Centre Plan Package A | Feedback Past Deadline Submissions

(Post May 8, 2018)

Centre Plan Review

Modelling select lots using draft Centre Plan Provisions

Appendix C

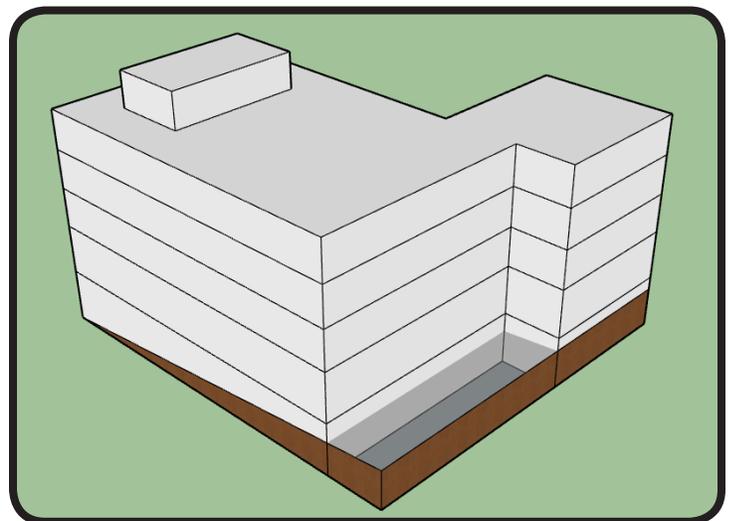
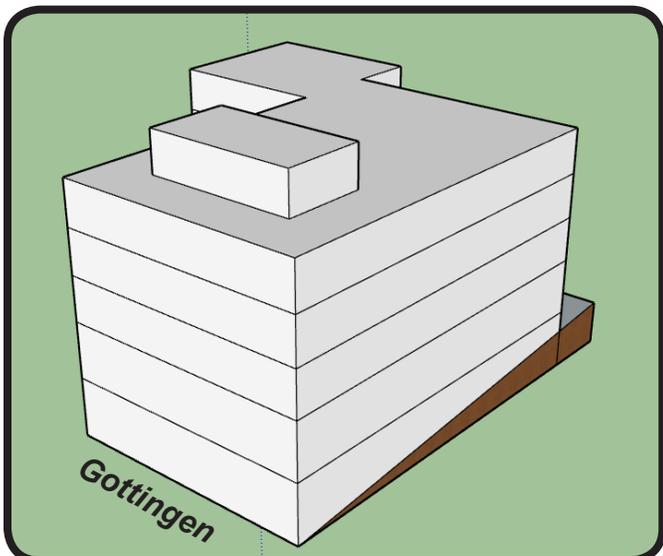
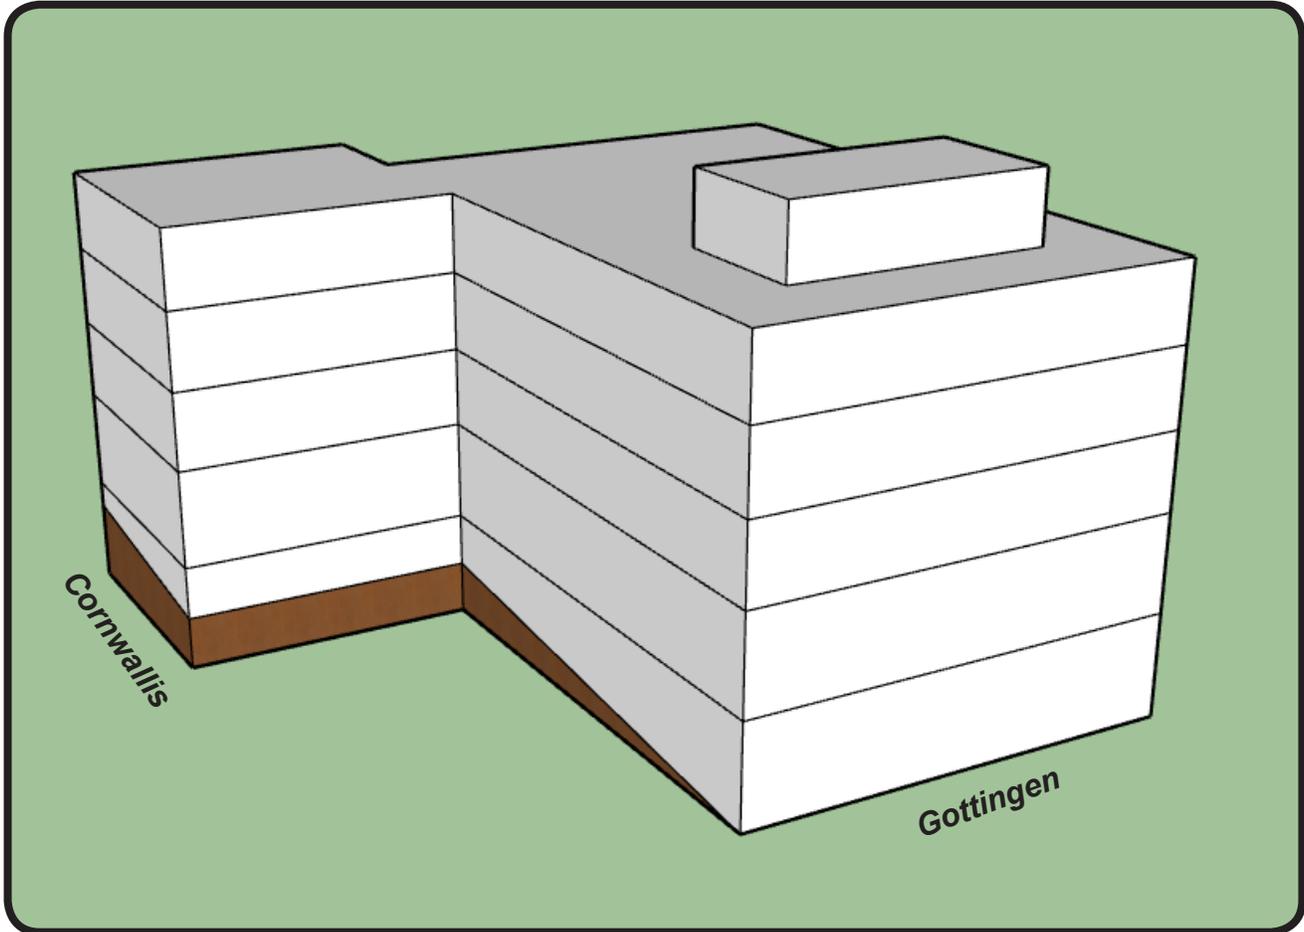
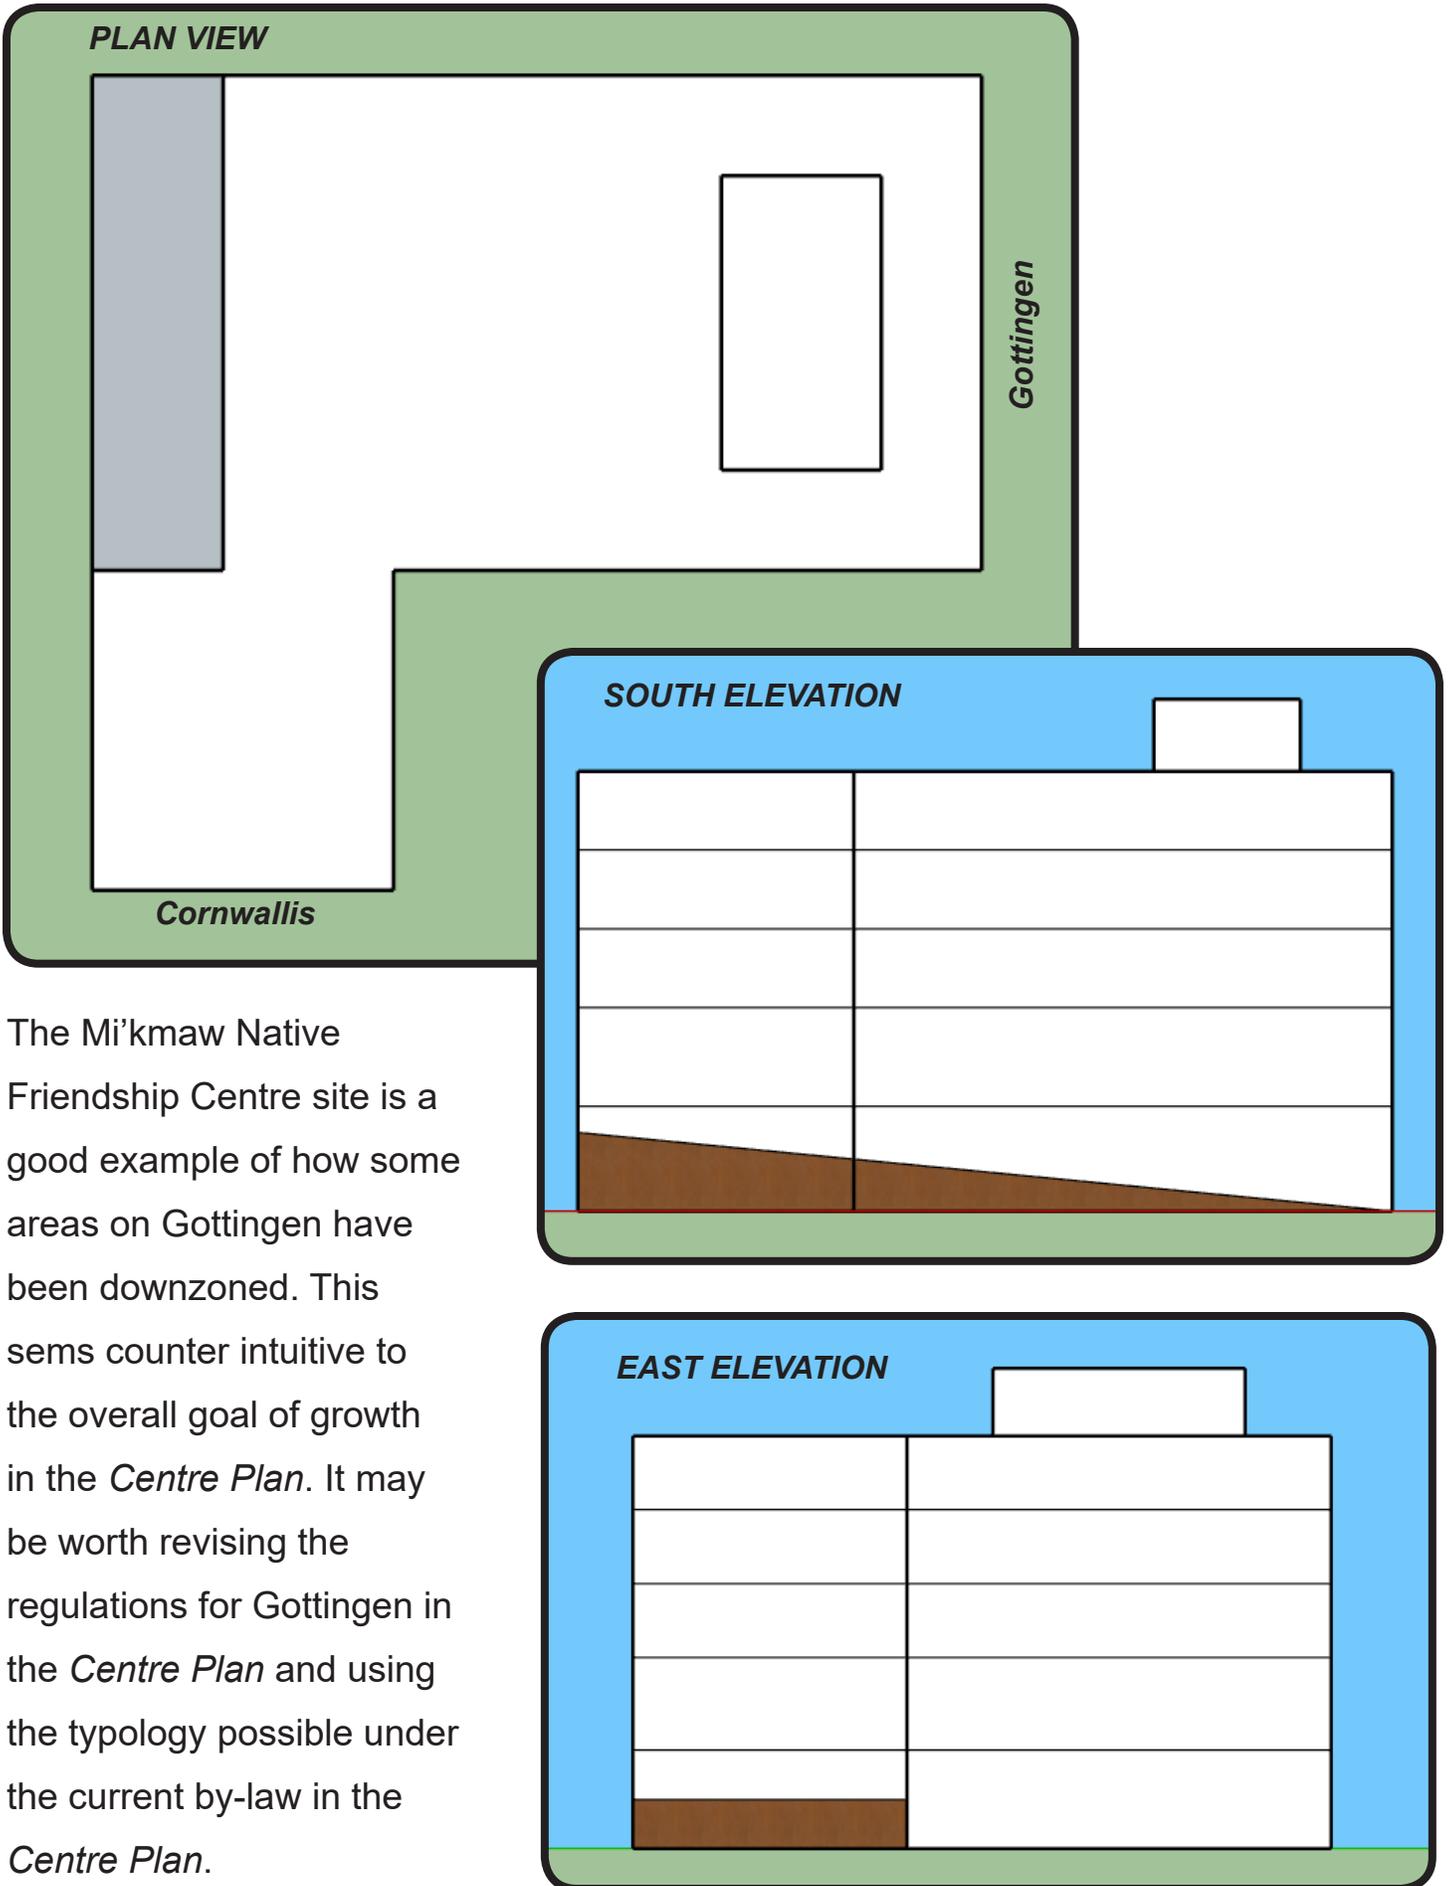
The following images show what would be possible under the current zoning regulations for Gottingen Street with a 50 ft height (starting at the midpoint of the grade on site, in this case 5 ft, total height from street is 55 ft), and a 10% penthouse. 15 ft was left at the rear of the building to allow for windows and units. The brown represents the change in grade on the site.

The Mi'kmaw Native Friendship Centre site is a good example of how some areas on Gottingen have been downzoned. This seems counter intuitive to the overall goal of growth in the *Centre Plan*. It may be worth revising the regulations for Gottingen in the *Centre Plan* and using the typology possible under the current by-law in the *Centre Plan*.
